Attachment D

Snowy 2.0 cyclic energy storage capacity is considerably less than 350 GWh

Schematic of Tumut and Snowy 2.0 Reservoirs (using Snowy Hydro’s stated volumes)

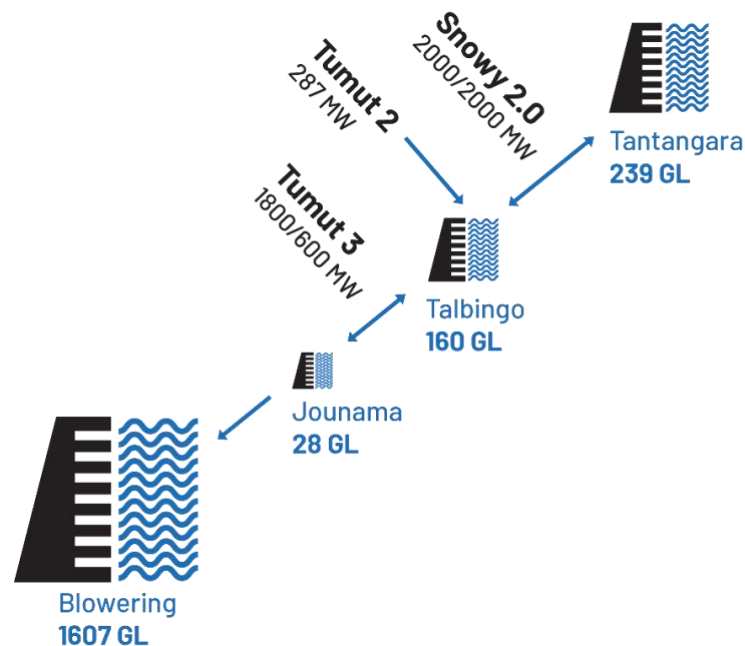
In the case of Snowy 2.0, the smaller reservoir, Talbingo, has only two-thirds the active storage capacity of Tantangara (160 GL versus 239 GL nominal). One-third of Tantangara water will not fit in Talbingo.

If Snowy 2.0 were a closed system its energy generating capacity would be determined by the generating capacity of two-thirds of Tantangara's 239 GL – i.e. 240 GWh (2/3x350).

However, Snowy 2.0 is not a closed system, contrary to the Snowy Hydro quote at the beginning of this Paper. In Snowy 2.0's case its recyclable energy generating capacity is substantially less than that determined by the volume of the smaller reservoir (Talbingo), due to complexities from integration with the existing Tumut Scheme (as explained later).
